**FORD:**  
2013 Fusion

Some 2013 Fusion vehicles equipped with a rear spoiler and built on or before 5/2/2013 may exhibit a concern of the luggage compartment lid will not stay open.

# TSB 13-5-18 (Continued)

Figure 2 - Article 13-5-18

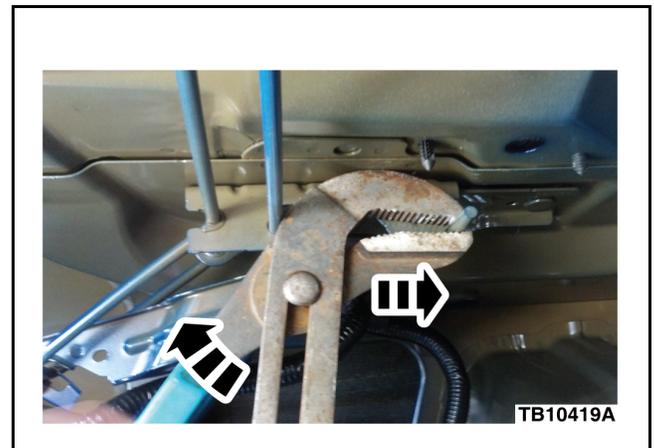
7. Hold torsion bar using large tongue and groove pliers, or equivalent. (Figure 2)

8. Lift up and push forward to remove the torsion bar from the bracket.
  - a. Release tension by allowing the tongue and groove pliers to slowly rotate forward. (Figure 2)
9. Remove the torsion bar from the opposite side hinge assembly and discard.
10. Repeat Steps 6-9 to remove the 2nd torsion bar.
11. Reverse removal Steps to install both torsion bars in the same orientation as removed.
  - a. Ensure torsion bars are installed in the lower notch. (Figure 3)
